ORIGINATION FORM

Proposed Revisions to a Standard Plans Index
(Please provide all information — Incomplete forms will be returned)

Index Number: 415-001
Sheet Number (s): 1
Index Title: Bar Bending Details (Steel)

Spiral

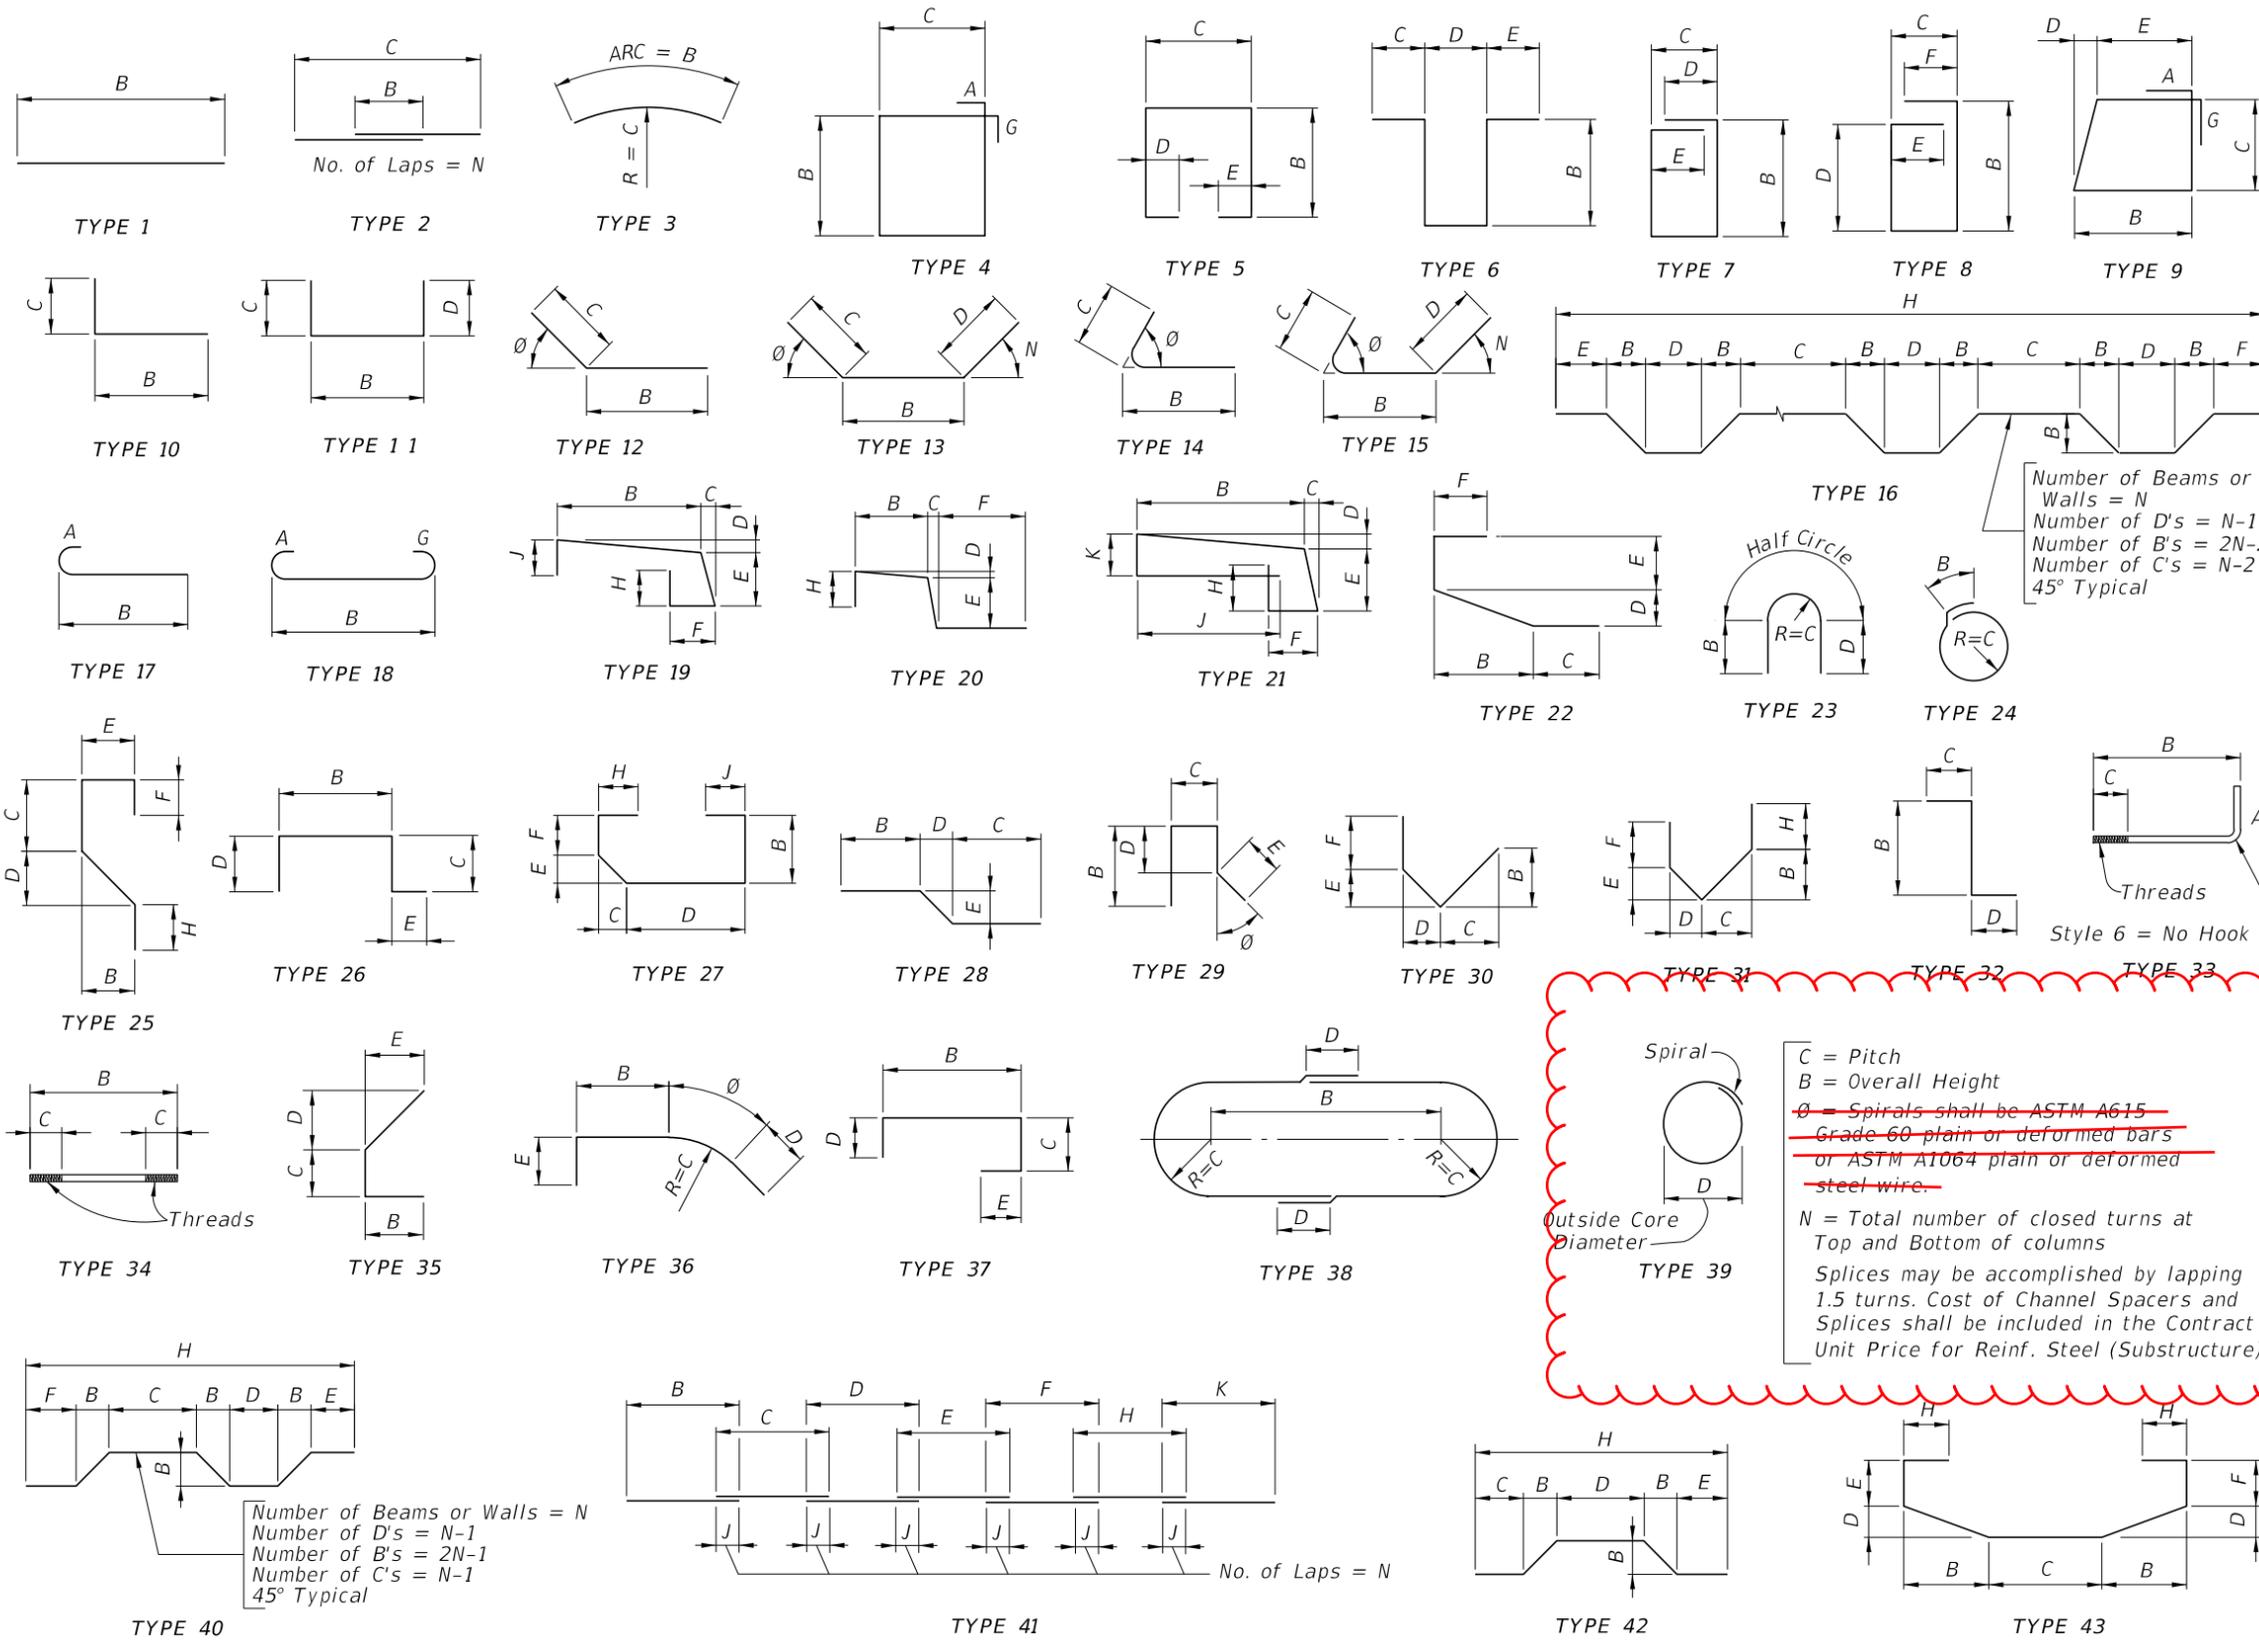
Delete phi for Type 39 spiral

C = Pitch
 B = Overall Height
~~Ø = Spirals shall be ASTM A615~~
~~Grade 60 plain or deformed bars~~
~~or ASTM A1064 plain or deformed steel wire.~~

Phi was the grade which is now covered in the standard and SDG. Bar or wire is at the contractors discretion.
